SUBJECT: ISSUANCE OF AMENDMENT NO. 11 TO FACILITY OPERATING LICENSE  
NO. NPF-3 FOR DAVIS-BESSE NUCLEAR POWER STATION, UNIT NO. 1

DAVIS-BESSE NUCLEAR POWER STATION, UNIT NO. 1

Amendment No. 11  
License No. NPF-3

ATTACHMENT TO LICENSE AMENDMENT NO. 11

Figure 2.1-2 Reactor Core Safety Limit

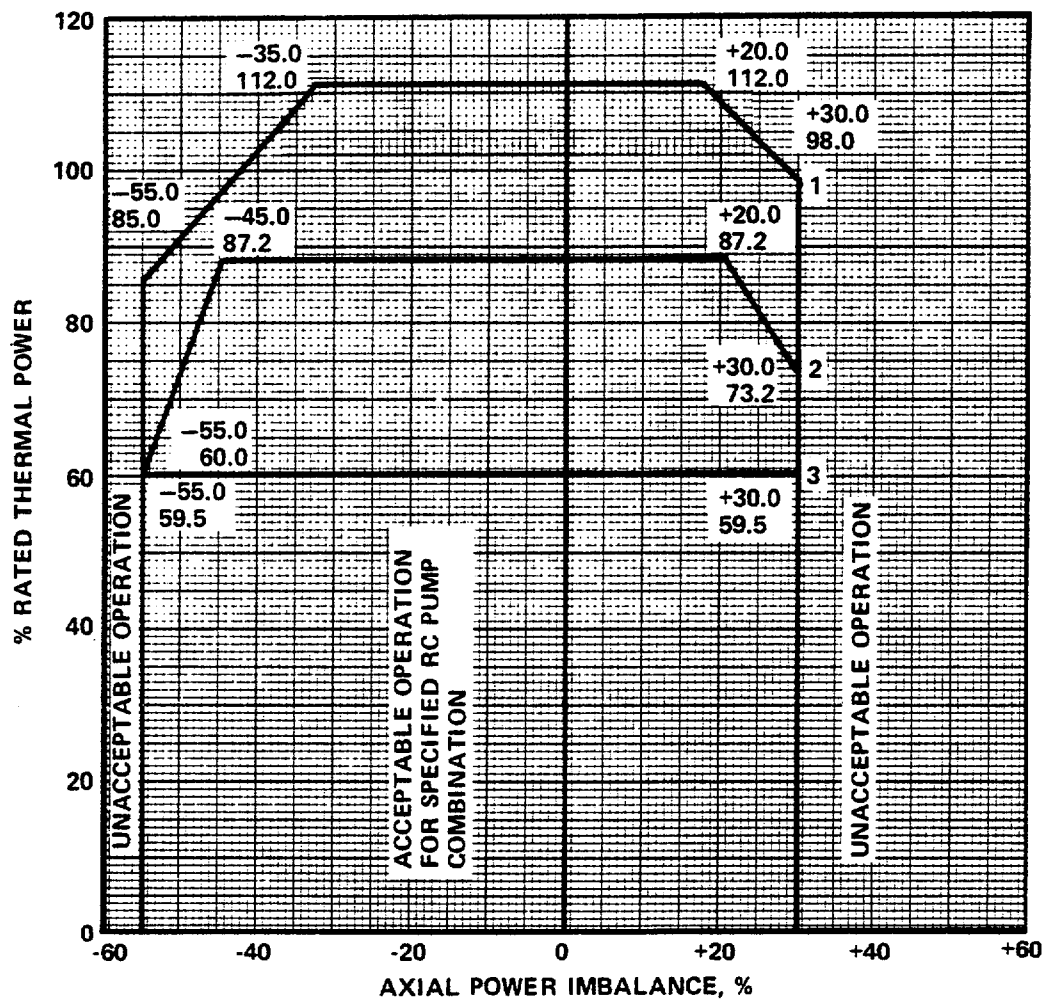
The new technical specifications have been established, using procedures which have been previously employed. New safety limits (Spec. 2.1.2) and Trip Setpoints (Fig. 2.2-1) and Allowable Values (Fig. 2.2-2) have been specified. New rod insertion limits (Spec. 3.1.2.6) have been specified along with new axial imbalance limits (Spec. 3.2.1) to ensure that peaking factor limits used as input to the LOCA-ECCS analysis are not exceeded. The rod program description has been changed (Spec. 3.1.7) to reflect the modification in group assignments. The maximum boration capability requirements (page B3/4 1-2) has been changed to reflect the reactivity changes resulting from the removal of the BPRAs and the relocation of the fuel assemblies.

CURVE	REACTOR COOLANT FLOW (GPM)
1	387,200
2	290,100
3	191,000

The specified flow rates for curves 1, 2, and 3 of Figure 2.1-2 correspond to the expected minimum flow rates with four pumps, three pumps, and one pump in each loop, respectively.

Figure 3.1-4

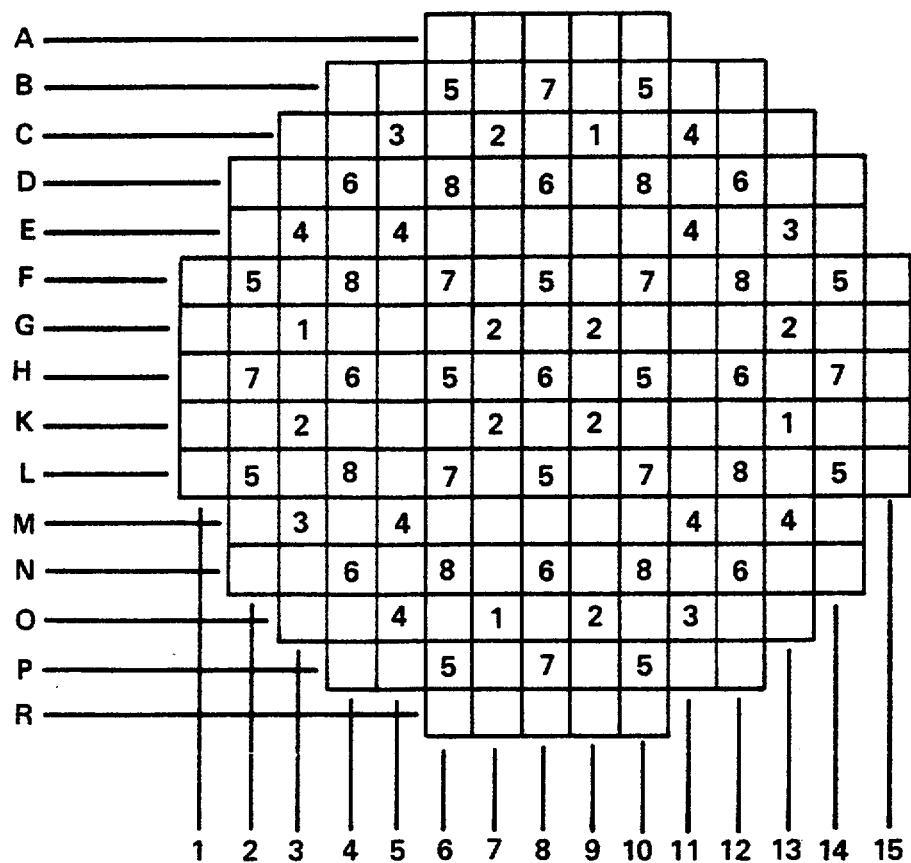
Because of the modification of core loading, some changes have been made in power distributions in the core. These changes necessitate changes in the technical specifications. Further changes are necessitated by the reprogramming of the rod groups.

3.1.3.7 Each control rod (safety, regulating and APSR) shall be programmed to operate in the core position and rod group specified in Figure 3.1-4.
